Section 4.55(1A) Modification to SSDA 9036 – Concord Hospital Redevelopment – MOD 6

This letter provides an addendum to planning assessment for proposed modifications at Concord Repatriation General Hospital on behalf of Health Infrastructure NSW (the Principal). Specifically, a Section 4.55(1A) Modification is sought to the approved State Significant Development Application (SSD No. 9036) for Concord Hospital Redevelopment.

Figure 2 Overall Plan – Basement (Proposed Modification 6 Plan)
Source: Jacobs Architects

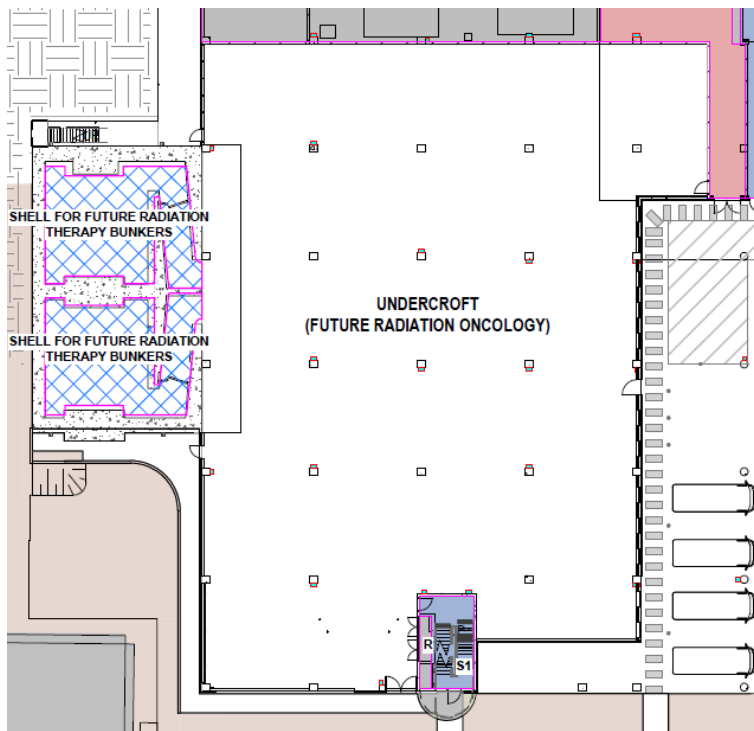
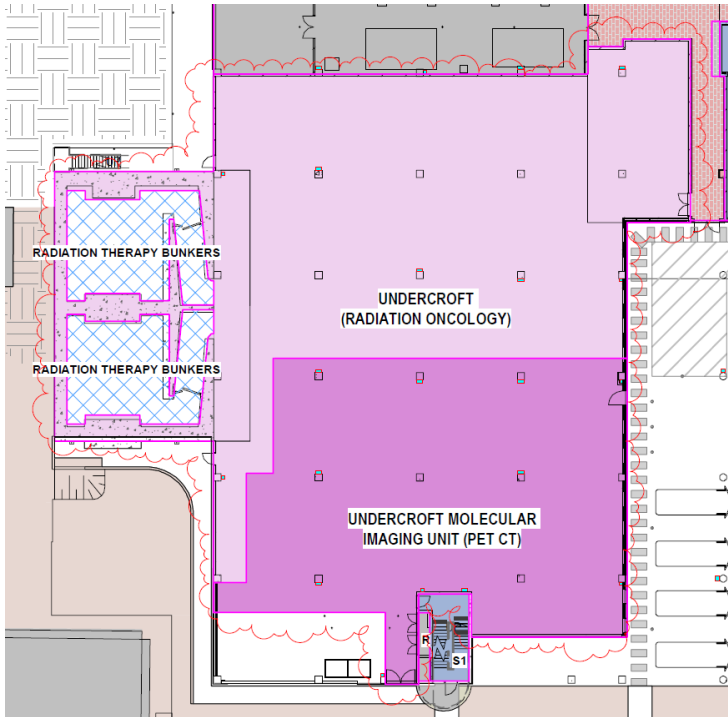
The scope of the proposed modification is for the internal fitout of the basement shell space into two tenancies for use as a radiation oncology unit and molecular imaging unit (positron emission tomography (PET) and computerized tomography (CT) suite).

A modification is required for the works as the proposed fit-out will occupy an area nominated as Future Radiation Oncology Shell, including Shell for Future Radiation Therapy Bunkers, on the approved plans.
